# THE RANCH SKETCH PLAN

SKETCH PLAN

#### Markup Summary 6-24-2019

COVER SHEET

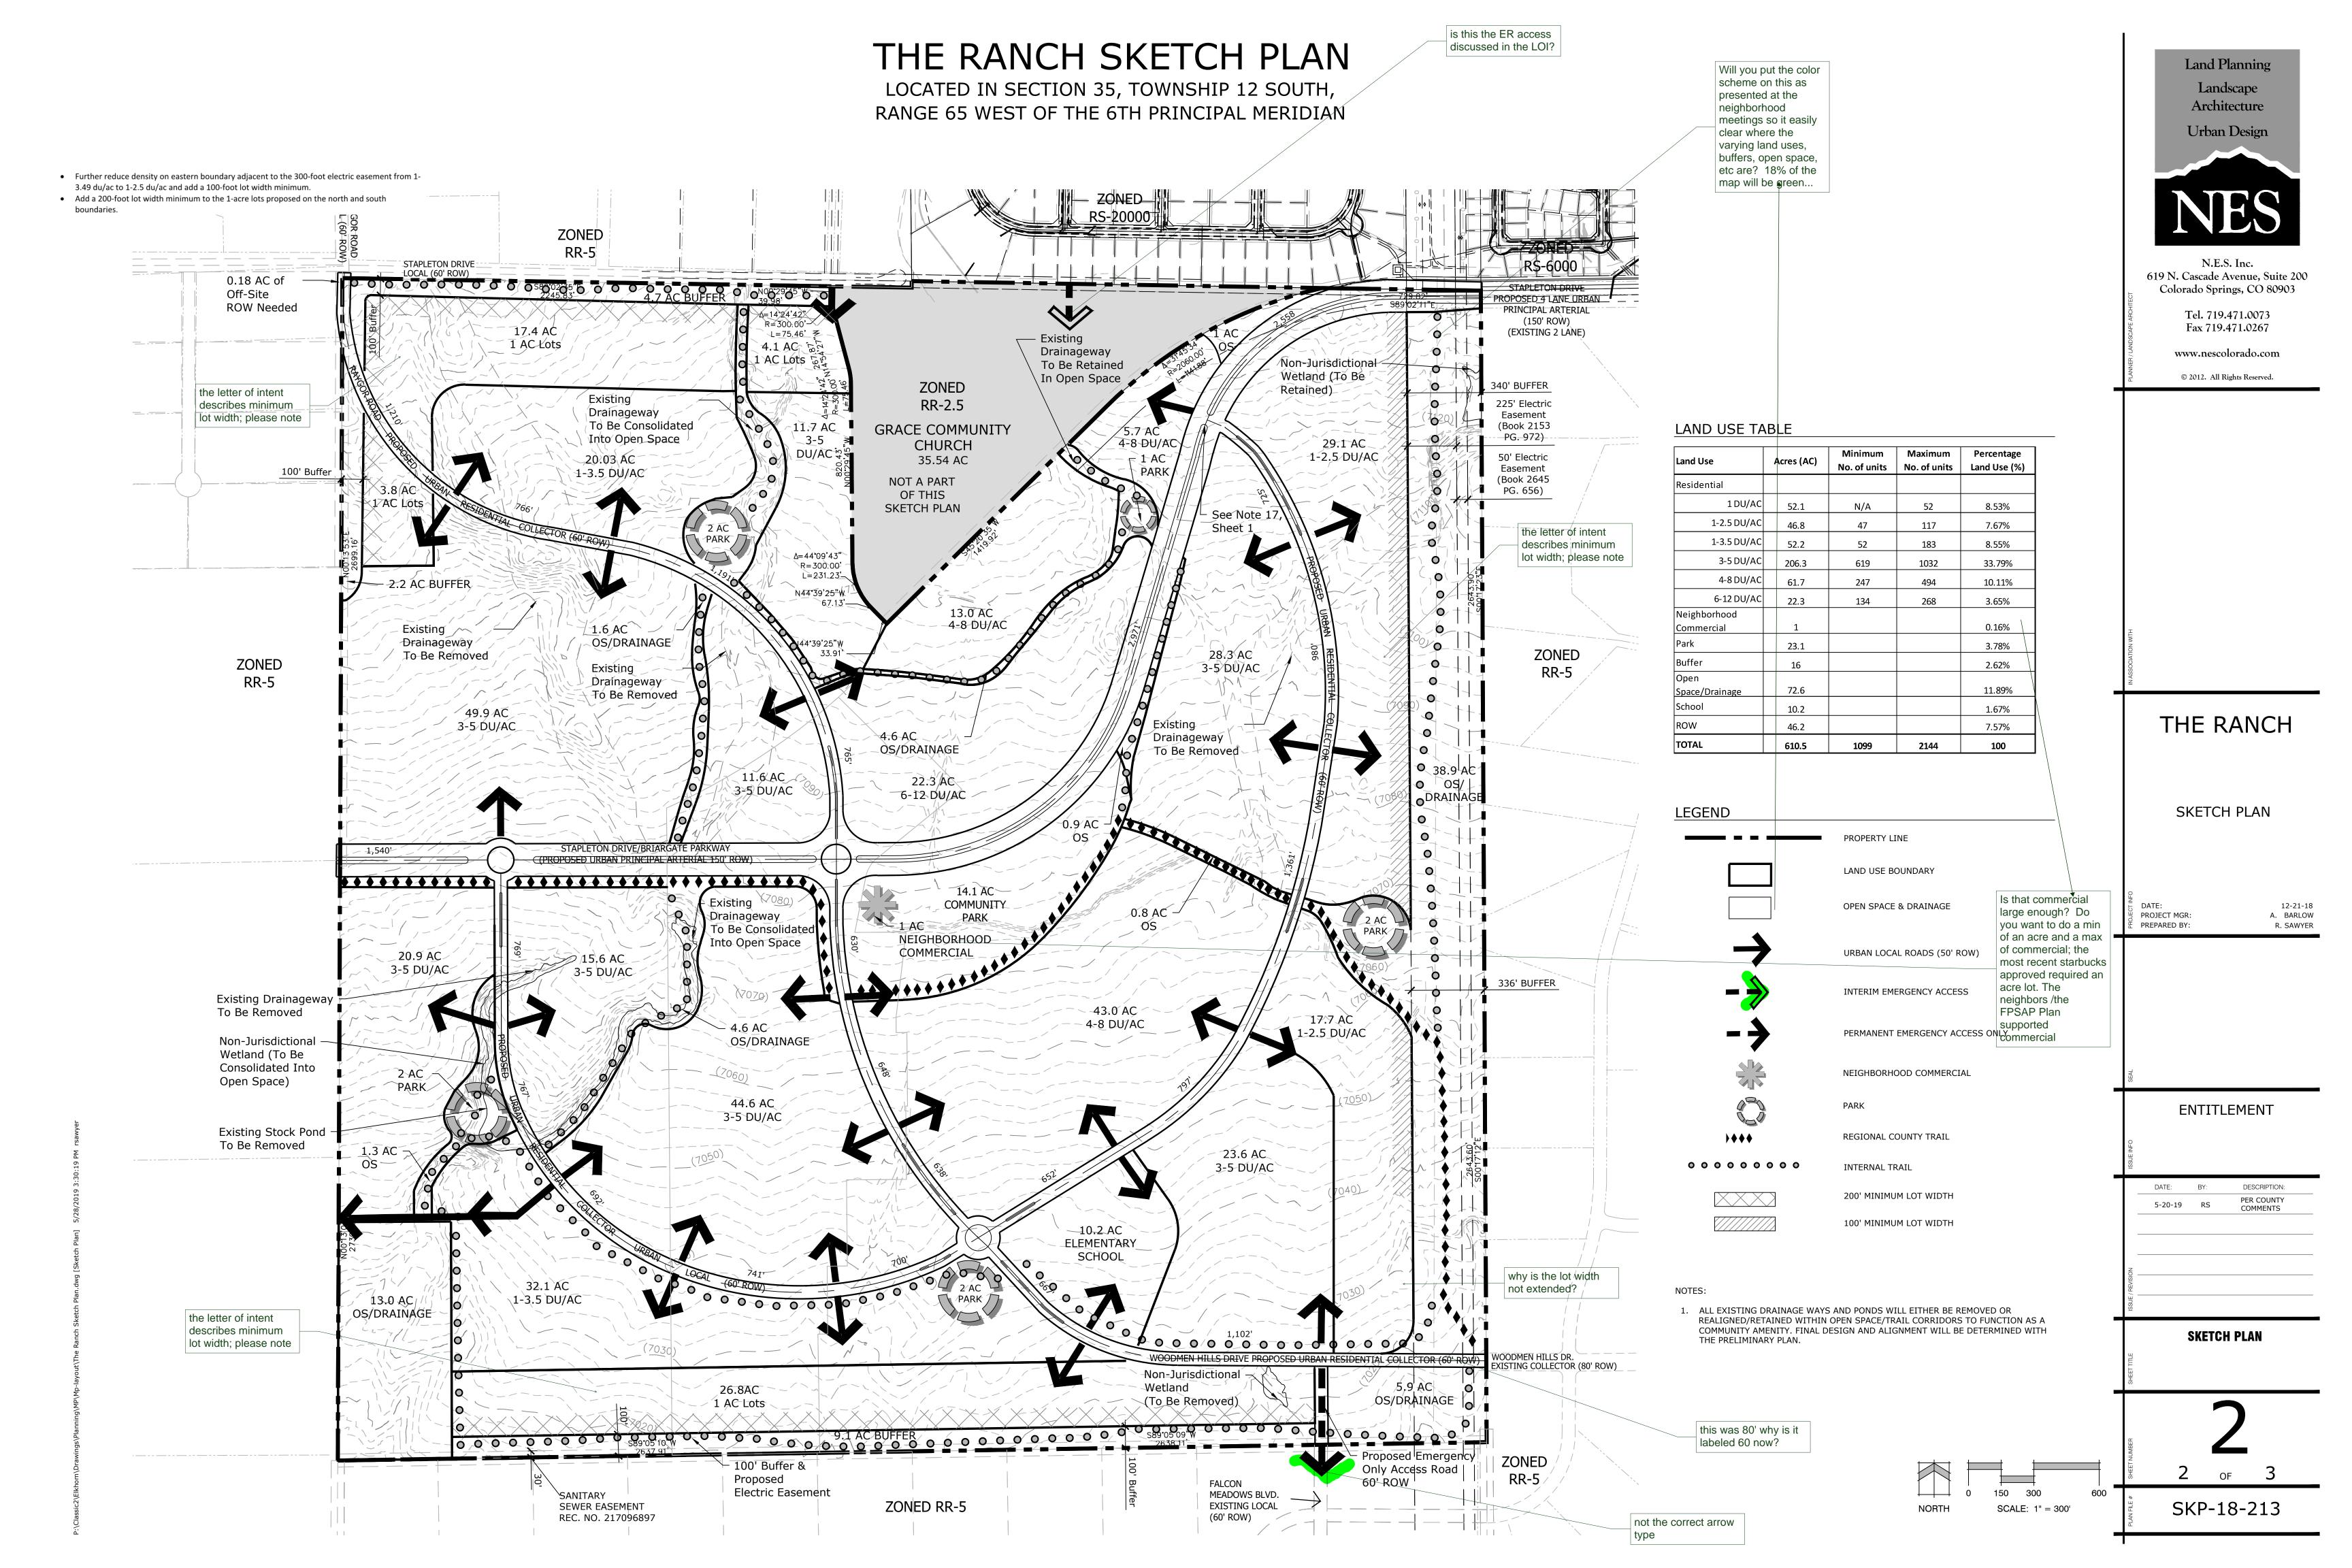
The noise study predicts noise mitigation please identify via a note or graphic (note remains from review 1)

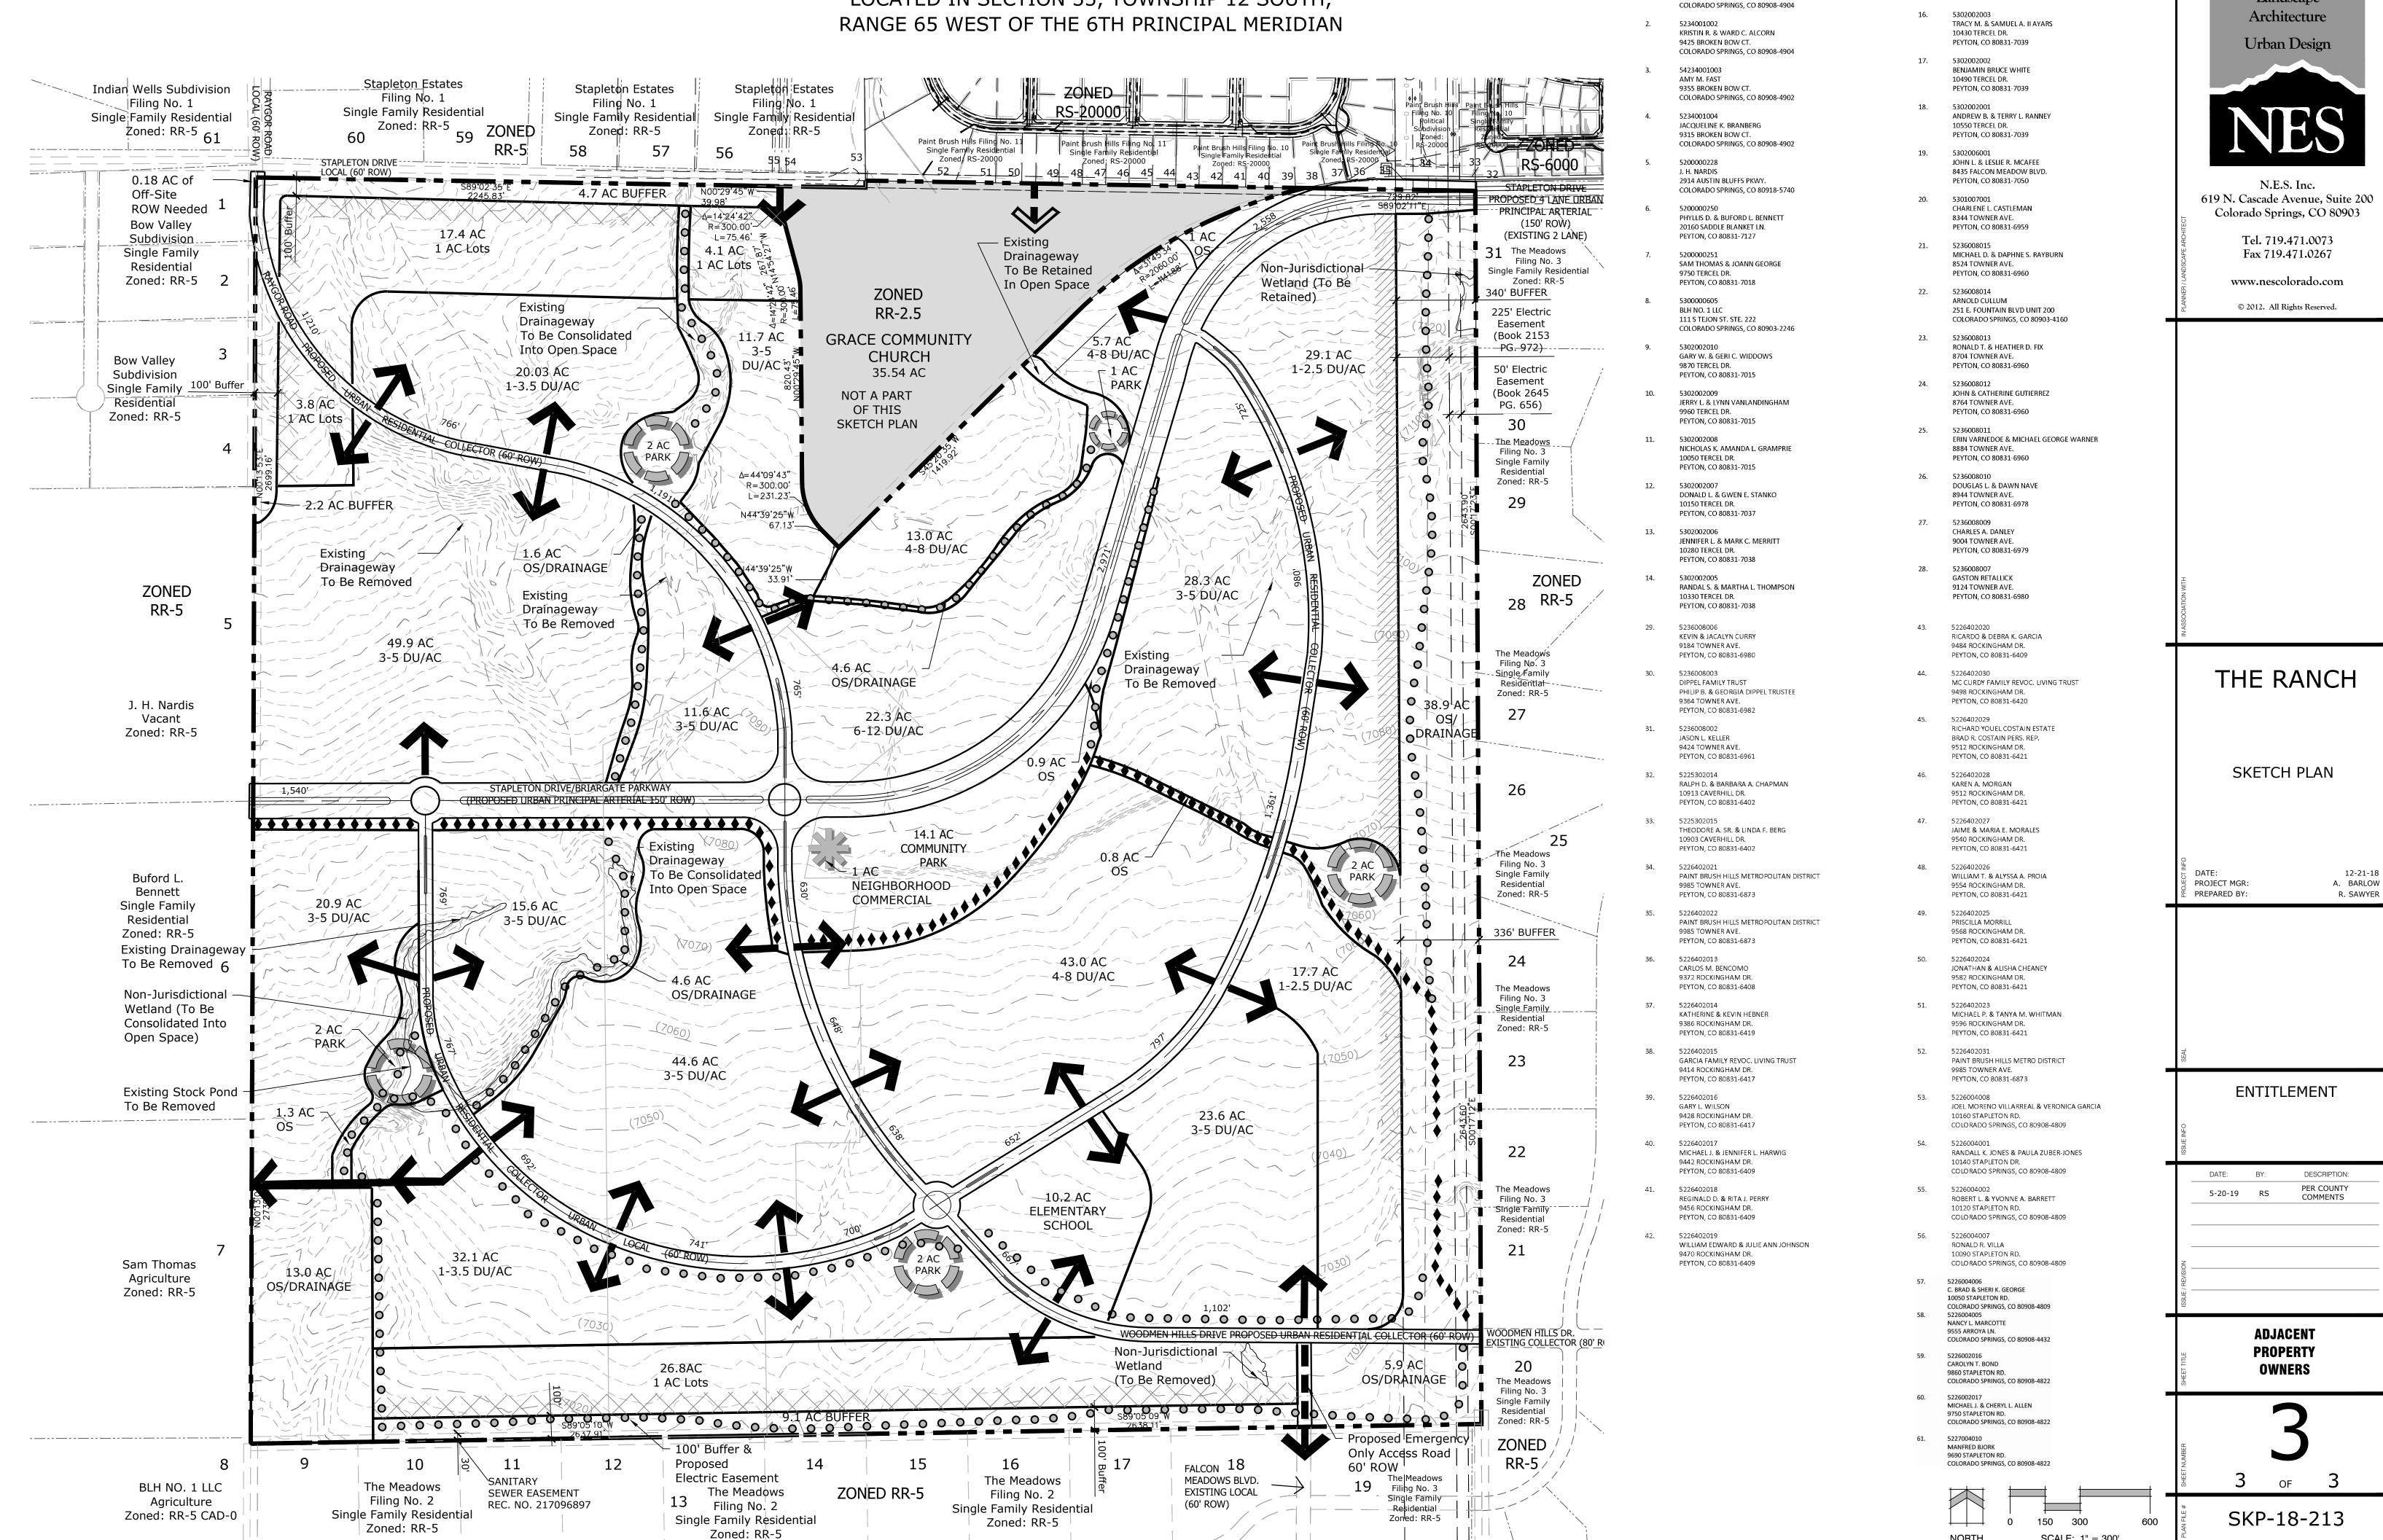
the letter of intent describes minimum lot width; please note

Will you put the color scheme on this as presented at the neighborhood meetings so it easily clear where the varying land uses, buffers, open space,

etc are? 18% of the map will be green...

Is that commercial large enough? Do you want to do a min of an acre and a max of commercial; the most recent starbucks approved required an acre lot. The neighbors /the FPSAP Plan supported commercial

not the correct arrow type

this was 80' why is it labeled 60 now?

why is the lot width not extended?

is this the ER access discussed in the LOI?
